DA 22/1494 2a Allen Ave Bilgola Beach 2107

Friday 28th October 2022

Our objection includes the following subjects and loss of amenities

See photo of the house and lower neighbouring houses in Allen Avenue, below

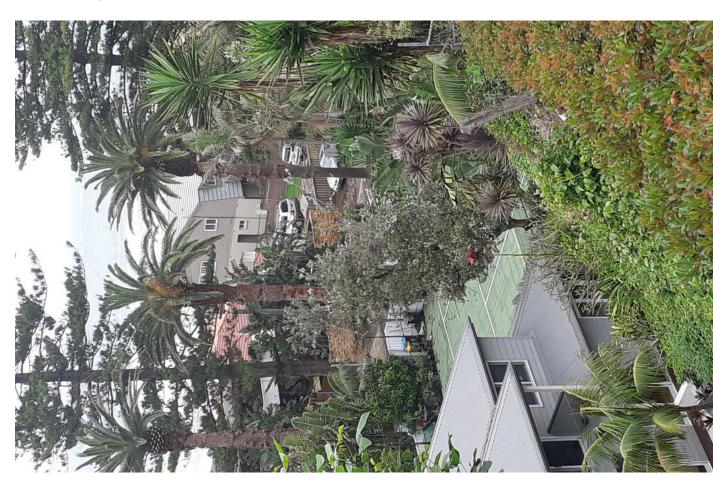
1. The existing house at 2a Allen Ave is already higher than its' neighbours as it is built on an elevated platform. At the time of purchasing our house (at 8 The Serpentine) we were told by council that the house directly to the east of us (2a) and other neighbouring houses could not be redeveloped any higher as they were already two storey and eight metres high. The current house is built on level ground and stands eight metres high.
